## APPENDIX 12

# UNITIZATION PROCEDURES FOR BOXED AMMUNITION AND COMPONENTS ON 4-WAY ENTRY PALLETS

CARTRIDGE, CALIBER .38, PACKED 1200 IN M2 SERIES  
METAL CONTAINERS, 2 PER WIREBOUND BOX, UNITIZED  
36 BOXES PER 40" X 48" PALLET; APPROX BOX  
SIZE 14½" L X 12¾" W X 8⅜" H

**PALLET UNIT**

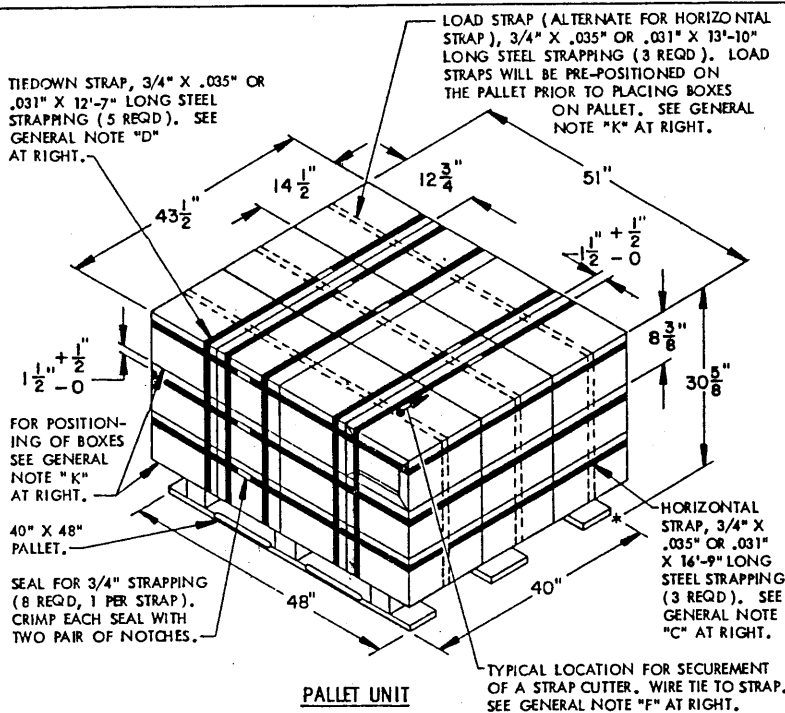
REVISION NO. 1, DATED JULY 1985, CONSISTS OF:

1. ADDING ALTERNATE LOAD STRAPS TO "PALLET UNIT" DRAWING.
2. ADDING GENERAL NOTES.
3. ADDING HAZARD CLASSIFICATION NOTE.

- K. WHEN LOAD STRAPS ARE USED IN LIEU OF HORIZONTAL STRAPS IN THE UNIT LOAD AT LEFT, POSITION THE THREE OUTBOARD BOXES ON THE 40" SIDES OF THE BOTTOM LAYER OF THE UNIT WITH THE TOPS DOWNWARD, AND THE THREE OUTBOARD BOXES ON THE 40" SIDES OF THE TOP LAYER OF THE UNIT WITH TOPS UPWARD.
